Planning & Development Report to
Calgary Planning Commission
2021 April 22

**Policy Amendment and Land Use Amendment in Beltline (Ward 8) at 1422 – 17
Avenue SW, LOC2019-0100**

**PROPOSED LAND USE AMENDMENT, AND BELTLINE ARP POLICY
AMENDMENT FOR MCDONALD'S RESTAURANT
LOCATED AT 1422 - 17TH AVNEUE SW (PLAN A1, BLOCK 116, PORTION OF
LOT 3, AND LOT 4 - 8)**

FIGURE 1: Collage of photographs of the exterior of the McDonald's site (taken March 27, 2021) demonstrating that only a minimal attempt was made to draw customers to the online engagement portal via the mandatory City of Calgary development notice signage.

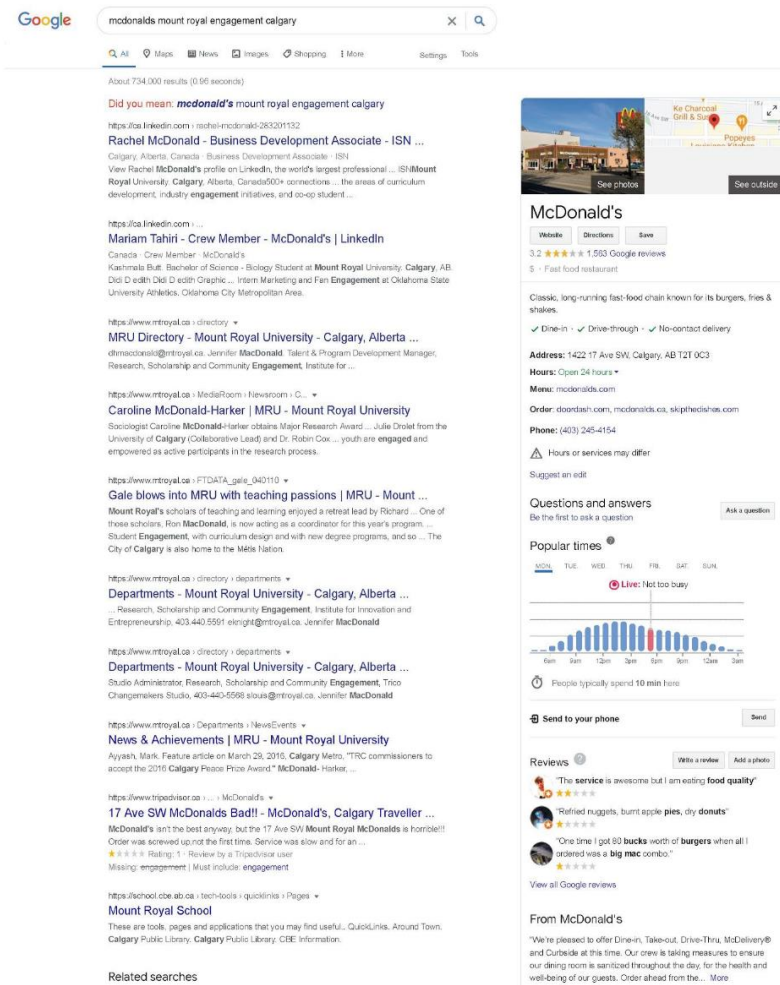
It does not appear that the engagement portal was widely advertised. The BNA did not find any references at the restaurant (apart from two City of Calgary land-use notices along 17 Avenue and 16 Avenue), and it was not possible to locate using logical web searches. We have appended two figures to this letter to demonstrate the concern. **Figure 1** is a compilation of photographs of the site taken on March 27, 2021 demonstrating the lack of

signage directing people to the engagement portal. **Figure 2** is a screen capture of a Google search that yielded to link to the site.
